STAFF REPORT
COMMUNITY DEVELOPMENT DEPARTMENT

HEARING DATE: 02/10/2026
TO: Mayor & City Council
FROM: Nick Napoli, Associate Planner
nnapoli@meridiancity.org
SUBJECT: Apex Northwest No. 7
FP-2025-0034
LOCATION: Near the northwest corner of S. Locust Grove Rd. & E. Lake Hazel Rd., in the E ½ of the SE ¼ of Section 31, Township 3N., Range 1E.

Final Plat consisting of sixty-four (64) single family building lots and eleven (11) common lots on 20.667 acres of land in the R-8 zoning district for the Apex Northwest Subdivision No. 7. Alternative Compliance to the pathway landscaping requirements in UDC 11-3B-12 for landscaping in the Williams Pipeline easement.

**PLAT OF
APEX NORTHWEST SUBDIVISION No. 7**
A parcel of land situated in a portion of the East 1/2 of the Southeast 1/4 of Section 33,
Township 3 North, Range 1 East, 8.M., City of Meridian, Ada County, Idaho
2023

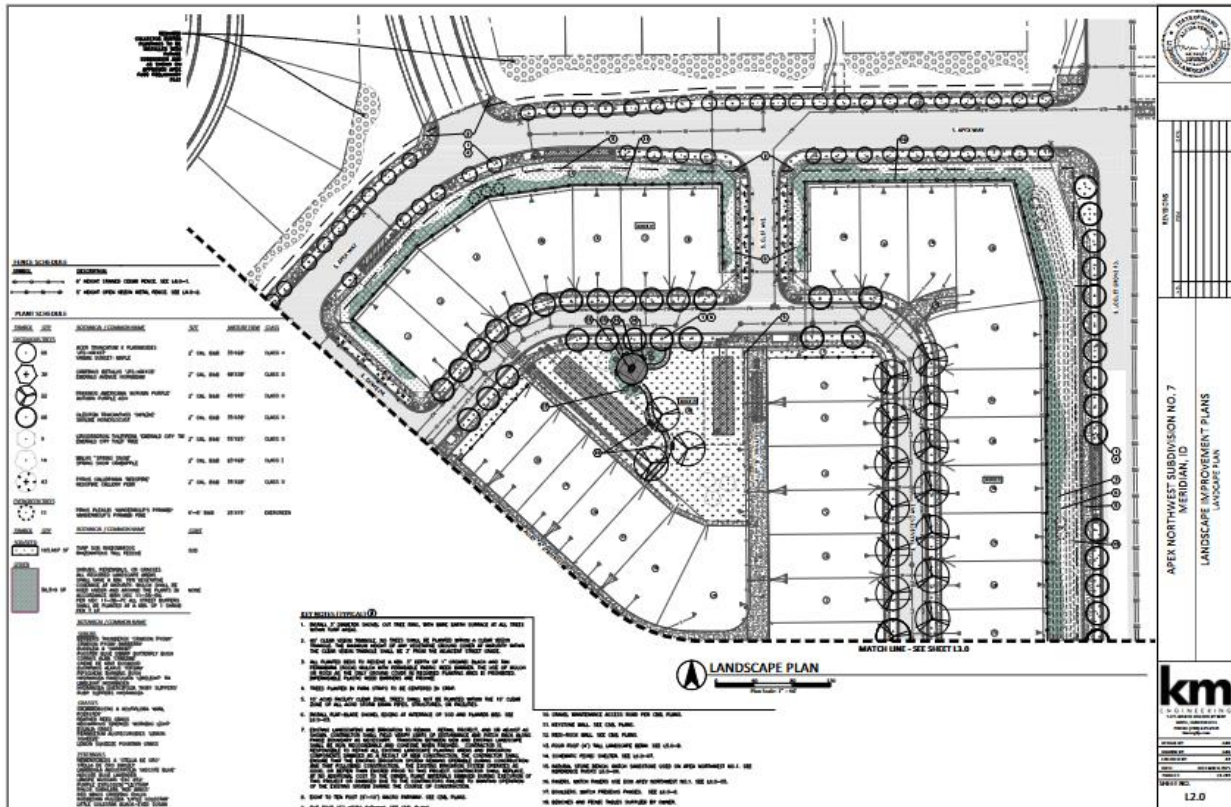
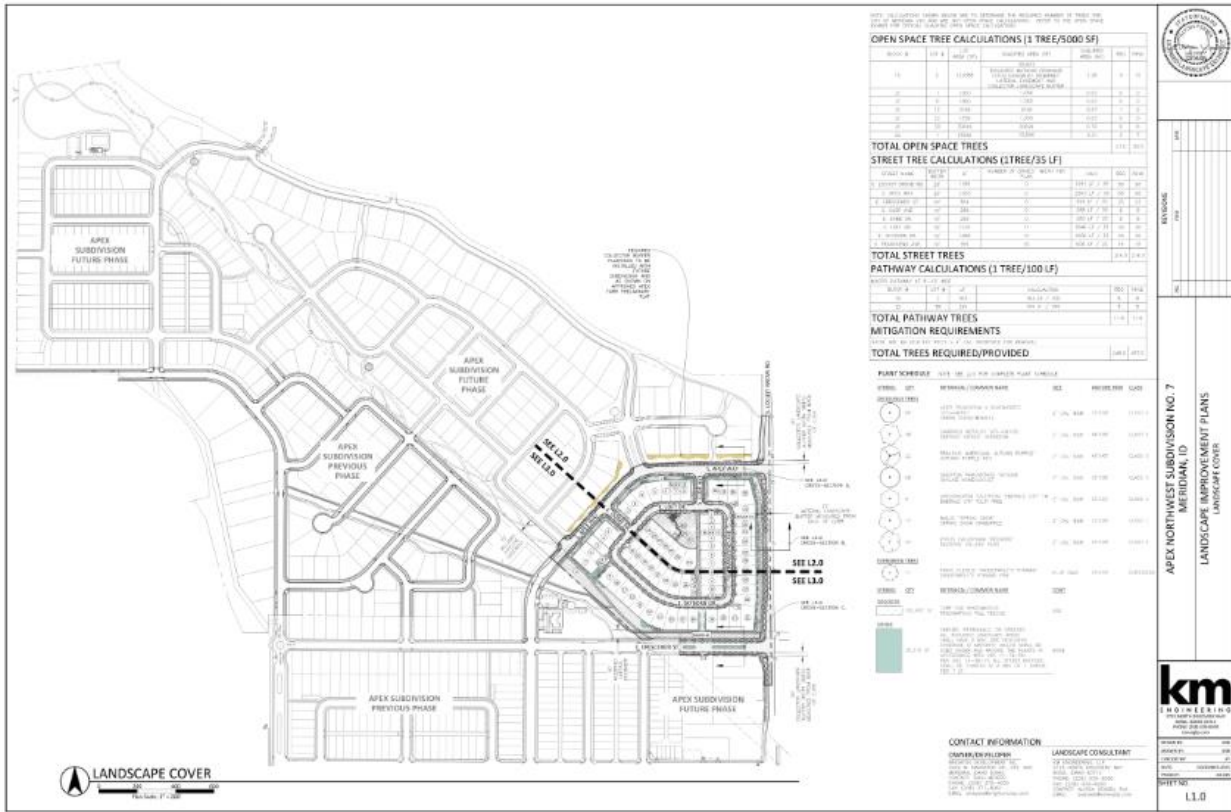
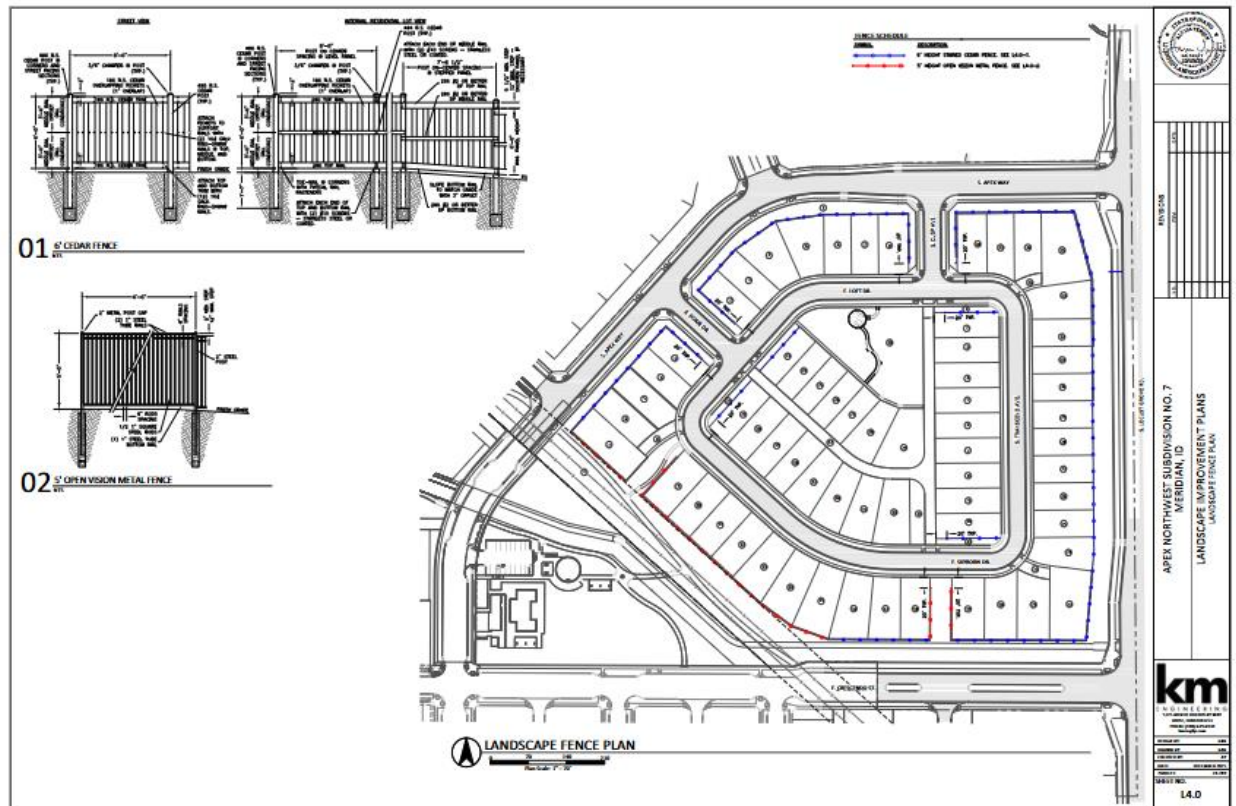
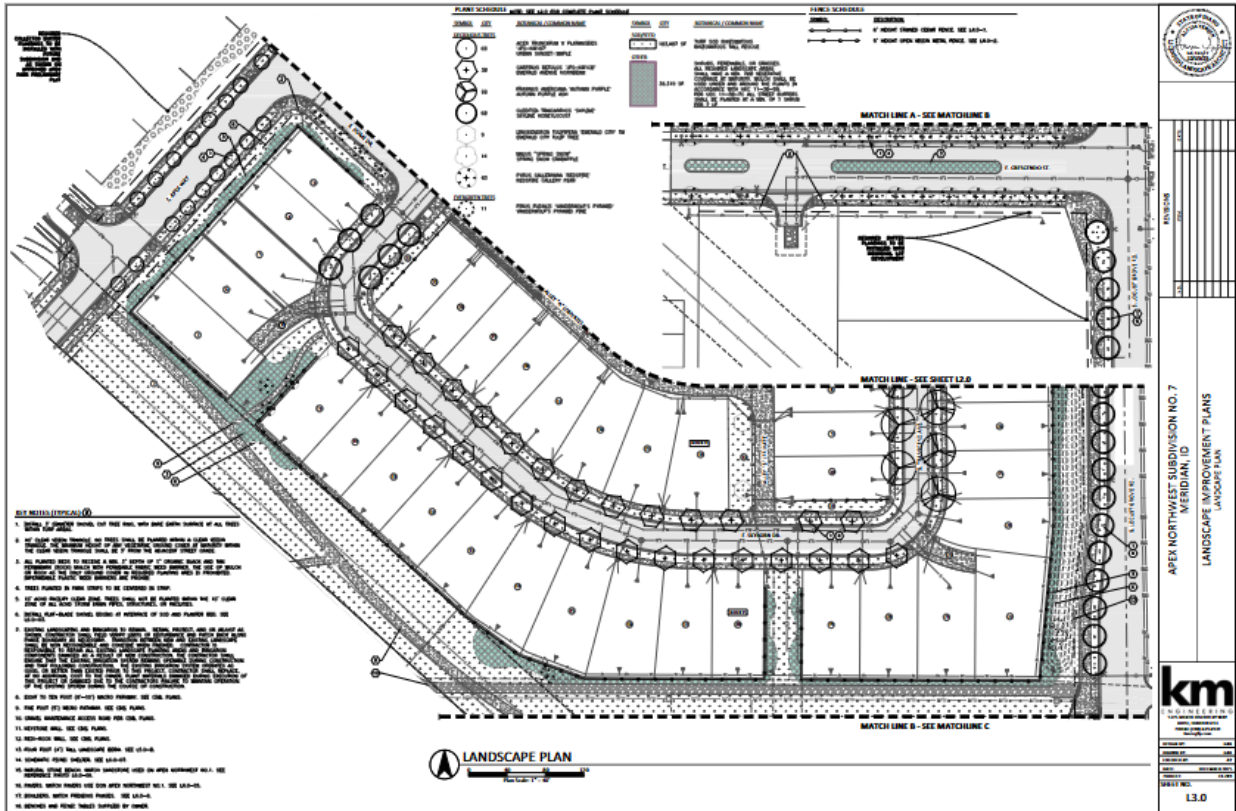
3. Prior to submittal for the City Engineer's signature, have the Certificate of Owners and the accompanying acknowledgement signed and notarized.
4. The final plat prepared by KM Engineering, dated: 12/15/2025, included in Section V.B shall be revised as follows:

- a. Note #10: Include the recorded instrument numbers for the ACHD temporary license agreement.
 - b. Note #11: Include the recorded instrument number of the ACHD permanent easement.
A copy of the revised plat shall be submitted with the final plat for City Engineer signature.

C. Landscape Plan (dated: 12/05/2025)

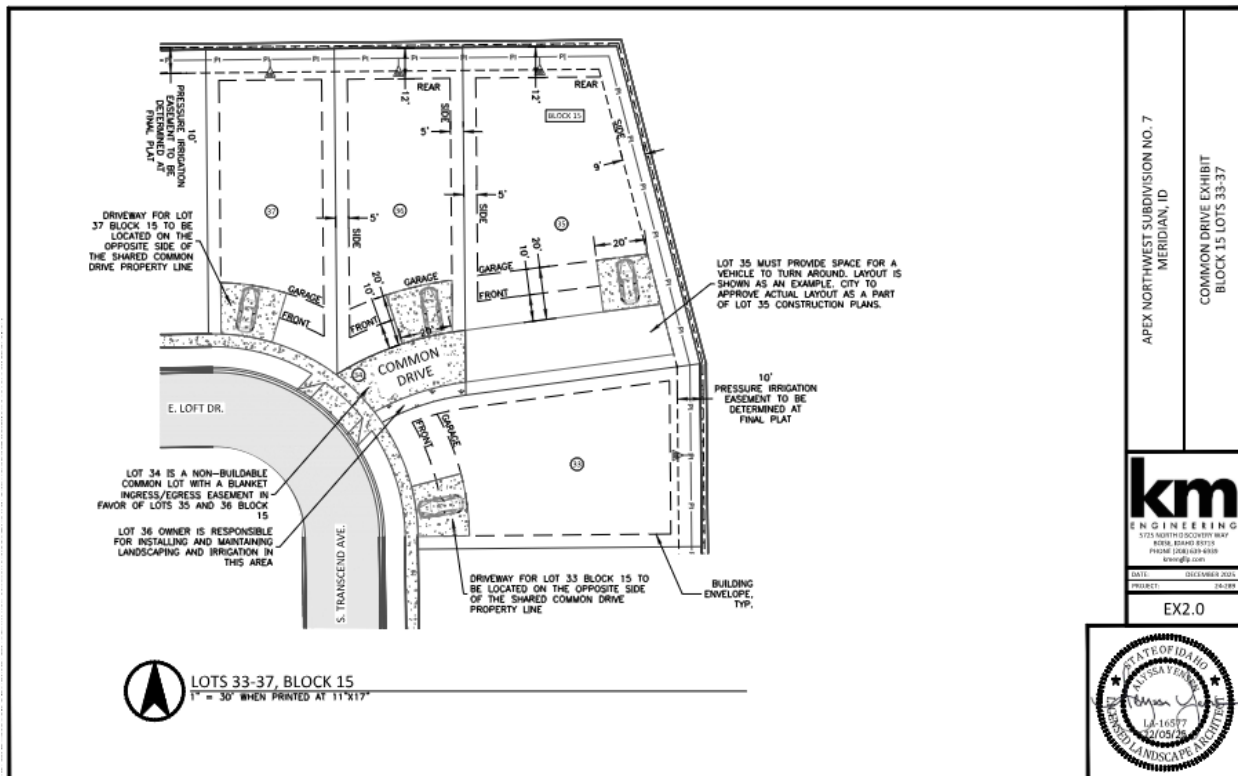
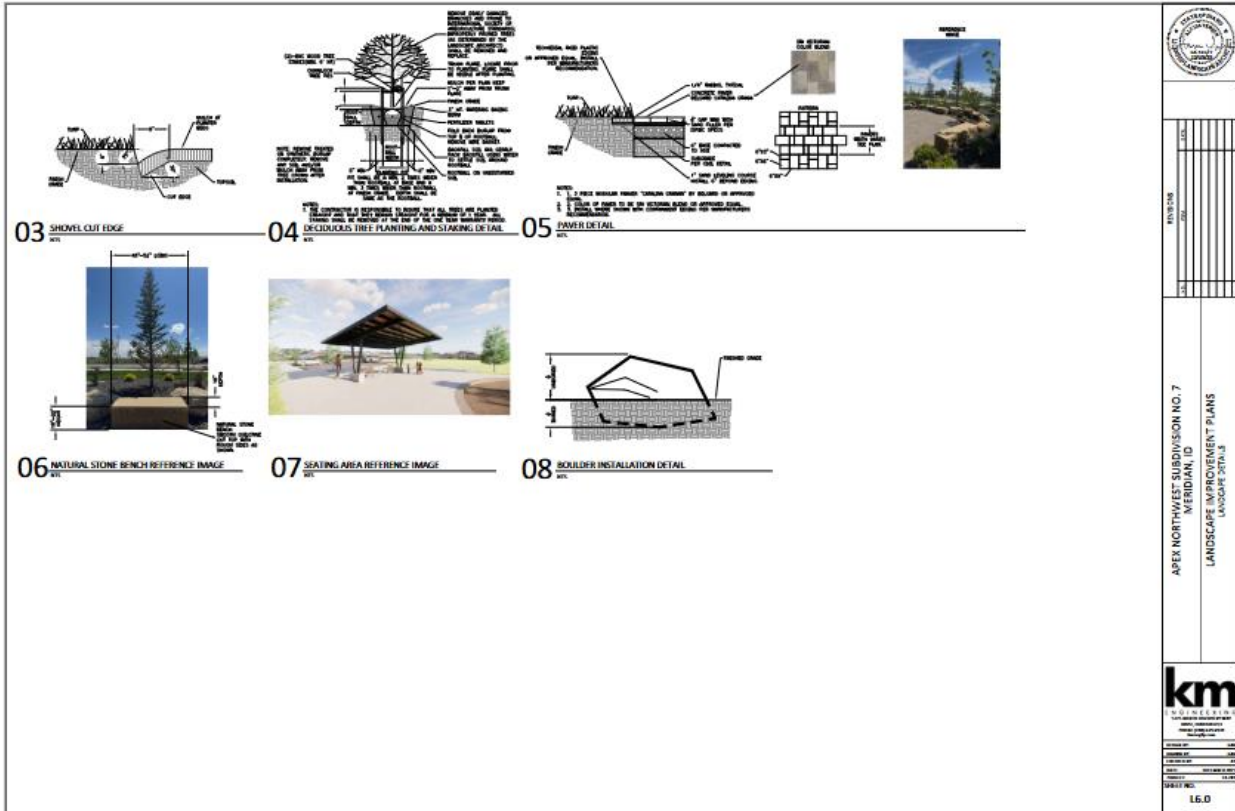
5. The landscape plan prepared by KM Engineering, dated 05/24/2024, included in Section V.C, shall be revised as follows:
 - a. Include trees, shrubs and lawn or vegetative groundcover along with the trees within the landscape strips along the multi-use pathway adjacent to the McBirney lateral in accord with the standards listed in UDC 11-3B-12C or apply for alternative compliance.

- b. All required landscape areas shall be at least 70% covered with vegetation at maturity, with mulch used under and around the plants in accord with UDC 11-3B-5N. Either depict detailed landscaping in the areas where a green cross-hatch symbol is used for shrubs, perennials or grasses that demonstrates compliance with this requirement; or, include a note in the plant schedule for the cross-hatched area that states compliance with this standard.

- c. Revise the landscape plan to meet the enhanced landscape buffer requirements along Collectors and Arterials as listed in the conditions for the Apex Farr development.

- d. Depict no parking signage on the landscape plan along the common drives in this phase of the subdivision.
6. Off-street parking is required to be provided for all residential units in accord with the standards listed in UDC Table 11-3C-6 based on the number of bedrooms per unit.
